# **Attachment C**

**Original Report to CSPC – 23 July 2020**

**Item 4.****Development Application: 163-173 McEvoy Street, Alexandria - D/2017/238/A****File No.: D/2017/238/A****Summary****Date of Submission:** 25 November 2019. Amended plans received on 12 May 2020.**Applicant:** Ceerose/Priansa Pty Ltd**Architect/Designer:** Andrew Burns Architecture and PBD Architecture**Developer:** Ceerose/Priansa Pty Ltd**Owner:** Priansa Pty Ltd**Cost of Works:** \$0**Zoning:** The site is zoned B4 - Mixed Use under the Sydney Local Environmental Plan (SLEP) 2012. The development is permissible with consent.**Proposal Summary:** This Section 4.56(2) application seeks to modify the concept approval for two mixed use building envelopes. The envelopes are labelled as 'Building A' fronting McEvoy Street and 'Building B' fronting Lawrence Street.

**Figure 25:** Proposed variation to building height - Building A and B (height control shown red dashed)

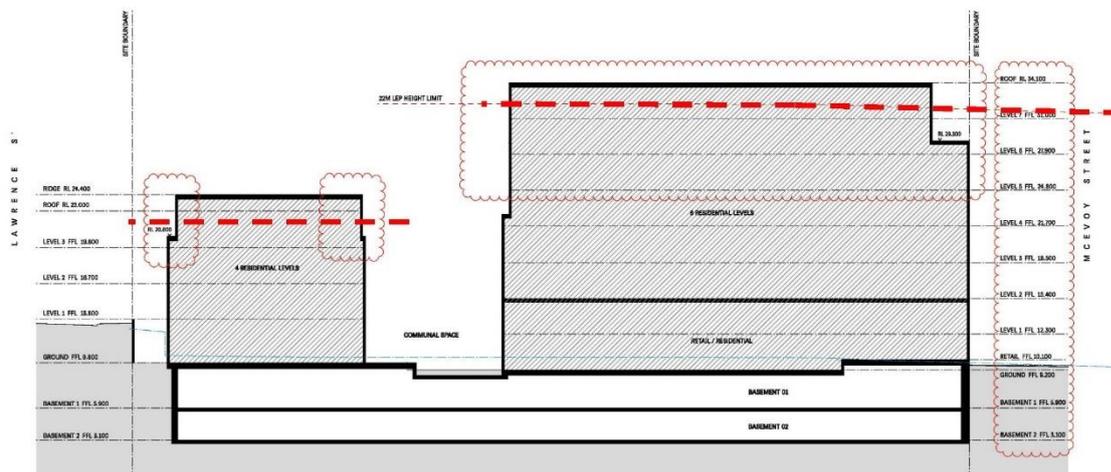
- (x) The additional height to Building A may result in up to 2 additional storeys. The original concept notionally approved 6 storeys, and the modification has the potential to deliver up to 8 storeys, as shown in Figure 25. Potential additional storeys would not result in a reduction in amenity as compliant floor to ceiling heights can be delivered for residential uses.

**Figure 29:** Proposed variation to building height - Building A

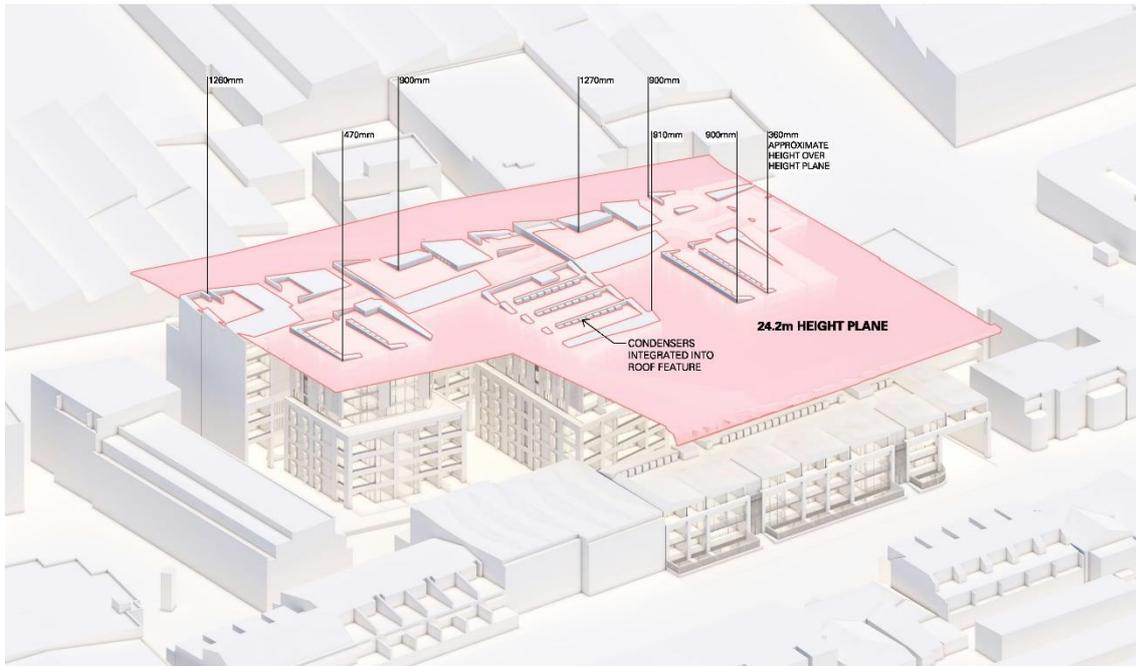
- (xii) In light of the above, the proposed increase in height of Building A is supported as the additional height will not result in additional impacts to adjoining properties or reduced amenity for future occupants.

- (iii) As demonstrated in Figures 29 and 30, the detailed design application seeks minor exceedances to the LEP building height control, which align with the modified RLs. These exceedances are confined to architectural roof features and integrated plant that does not create unacceptable overshadowing to adjoining properties or unreasonably add to the bulk and scale of the building when viewed from the public domain and surrounding buildings.

**Figure 30:** Proposed variation to building height - Building B

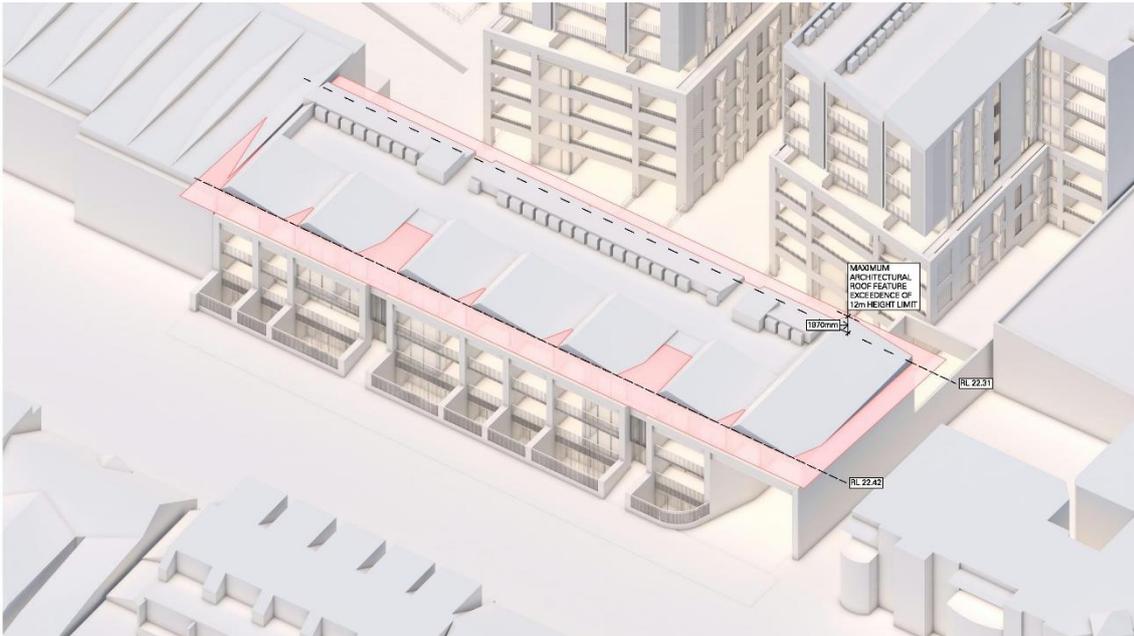
- (b) Increase in height of Building B
- (i) The concept approval set maximum building heights in RLs that corresponds to a building that presents as 3 storeys to Lawrence Street and 4 storeys to the internal courtyard.
  - (ii) The application proposes exceeding the maximum 12m LEP height of building development standard by 1.97m. The extent of the non-compliance is illustrated in Figure 25.
  - (iii) Notwithstanding the proposed height increase, the modified envelope retains the 3 storey form to Lawrence Street and 4 storey form to the internal courtyard, as per the original concept approval. The proposed additional height will not accommodate any additional storeys on Building B.
  - (iv) Submitted shadow diagrams indicate that the additional height will not create unacceptable impacts on surrounding properties with regard to solar access.

- (v) In light of the above, the proposed increase in height of Building B is supported as the additional height is not expected to result in additional impacts to adjoining properties or reduced amenity for future occupants.
- (vi) The modified envelopes are also capable of delivering a built form that is consistent with the existing and future desired character of the area. This is demonstrated by the detailed design application. As illustrated in Figure 30, the area of non-compliance with the LEP building height control is relatively minor and as it is confined to an architectural roof feature, does not unreasonably add to the bulk and scale of the building when viewed from the public domain and surrounding buildings.

**Figure 31:** Ground floor amended envelope with approved concept envelope (red) and required ADG building separation to adjoining property boundaries (blue). The diagram illustrates the change to the bays of Building A

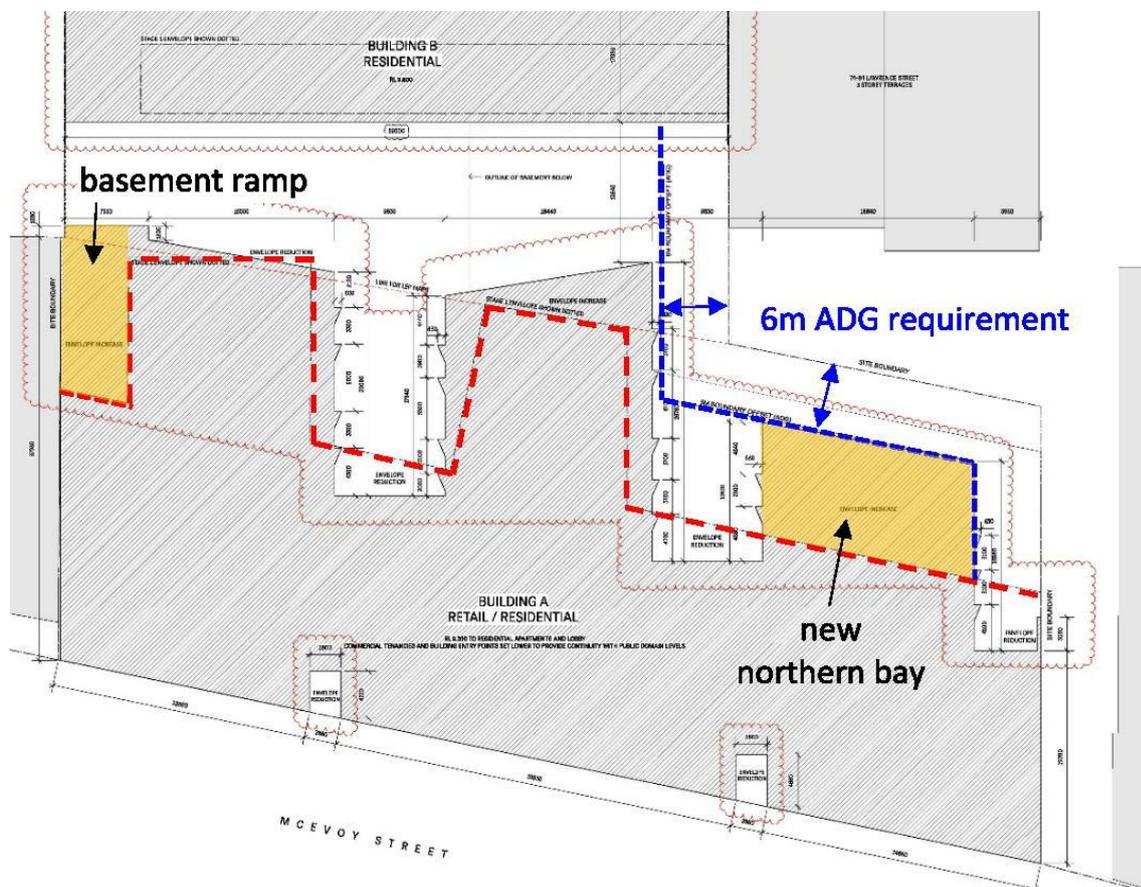
- (i) As shown in Figure 31, the proposal infills the separation between the southern bay and the south-western property boundary at the ground floor to allow for driveway access to the basement (shaded yellow in Figure 31). This increase is confined to a single storey and is acceptable.

- (iv) The new northern bay (shaded yellow in Figure 31) provides between 6m and 6.8m between the bay and the northern property boundaries at lower levels (G to Level 3) and between 7.8m and 9.5m at upper levels (Level 4 to 7).
- (v) The angled ends of the bays to Building A provides an overall separation distance of between 10.3 and 15.6m between Building A and B.
- (vi) As shown in Figure 31 and 32 the proposal generally complies with the recommended building separation distances outlined in the Apartment Design Guideline and it is considered that an acceptable level of amenity and privacy can be delivered for future occupants and adjoining properties.
- (vii) Where separation distances are not achieved, the detailed design proposal demonstrates that design features can be developed that ameliorate visual privacy concerns for future occupants and adjoining properties.

**Figure 32:** Level 4 amended envelope with approved concept envelope (red) and required ADG building separation to adjoining property boundaries (blue)

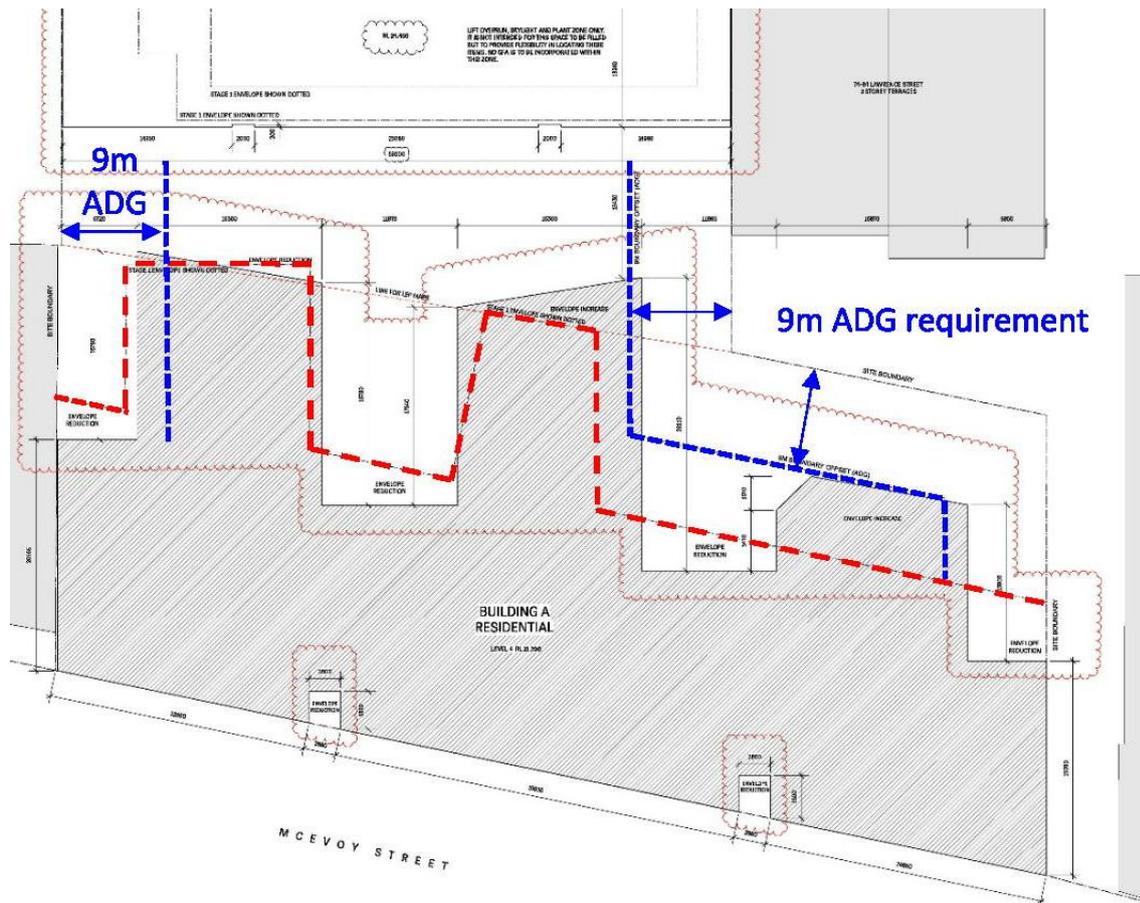
- (ii) As shown in Figure 32, the proposal increases the separation between the southern bay and the south-western property boundary for Level 4 upwards. This increase is from 6m approved under the original concept plan to 7m under the proposed modification.

- (iii) The middle bay has been increased in width and length to provide a minimum of 9.8m between the each of the three bays of Building A at lower levels (G to Level 3) and 11.9m at upper levels (Level 4 to 7).

**Figure 33:** Level 3 amended envelope with infill to south-western property boundary of Building B shown in yellow

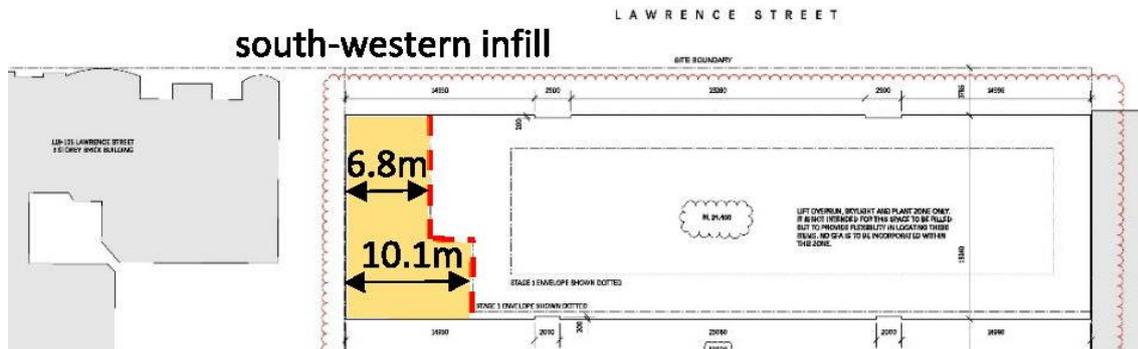
- (d) Enlarge the footprint of Building B to meet the south-western property boundaries.
  - (i) As shown in Figure 33, the modification infills the separation between the approved envelope and the south-western property boundary (indicated in yellow). This infill is in the order of 6.8m at Levels 1 and 2 and increases to 10.1m for a portion of Level 3. This increase is largely to allow an integrated access to the basement.

- (ii) The enlargement of the footprint of Building B to meet the side boundaries facilitates a development that is consistent with the existing streetscape. Lawrence Street is characterised by terraces (both traditional and contemporary) built to the boundary.

**Figure 34:** Minimum 5m setback to glass line

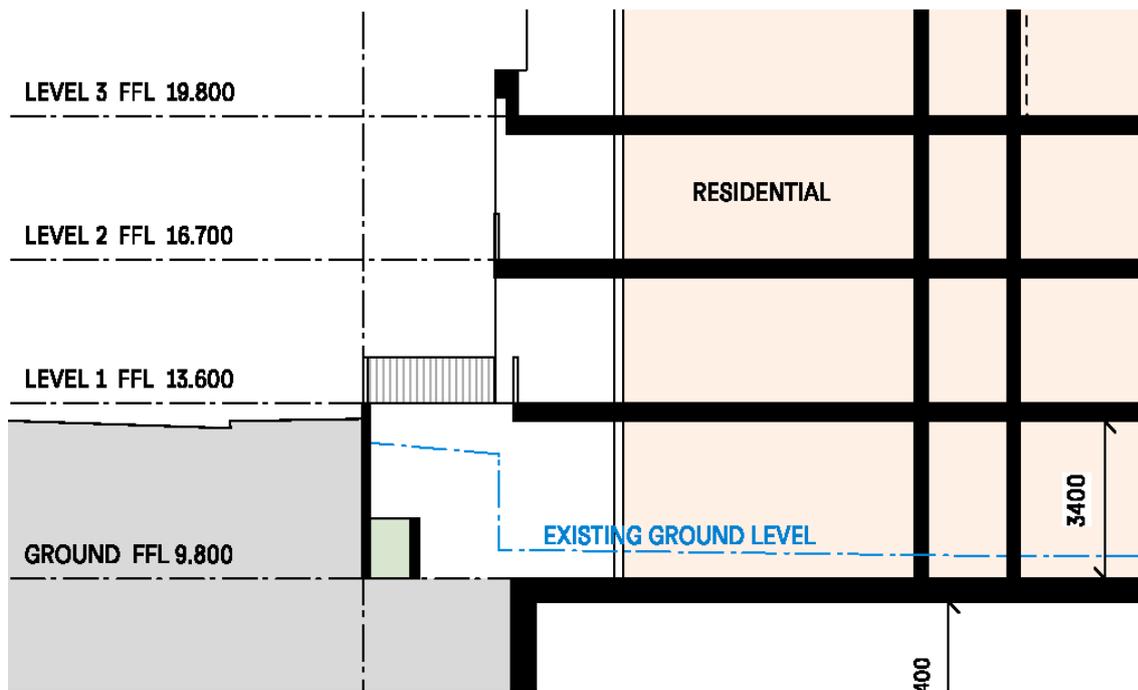
- (a) Condition 5(k) and 5(l) Subterranean Units
- (i) Conditions 5(k) and 5(l) restricted the inclusion of habitable space within the north and western portion of the ground floor of Building B due to its subterranean location.
  - (ii) The modification proposes the deletion of these conditions to allow for the provision of apartments on the ground floor fronting Lawrence Street.
  - (i) A key concern for subterranean apartment includes amenity, including access to sunlight and outlook.
  - (ii) The proposed envelopes are provided with a setback from the Lawrence Street property boundary that can achieve adequate levels of privacy and amenity. Further, the amenity of the below ground apartments proposed within the detailed design application has been assessed and is acceptable.

- (iii) In summary, the apartments are either maisonette apartments or through apartments, with living, dining and kitchen areas orientated towards the central courtyards on the Ground floor or are located on Level 1, allowing solar access to living spaces. Uses located below street level are limited to bedrooms, with a setback of minimum 5m from the property boundary to the glass line allowing natural light and ventilation into these rooms as well as space for landscaping (see Figure 34). Integrated screening is also proposed to control privacy, outlook, and access to light and ventilation without creating a sense of enclosure.
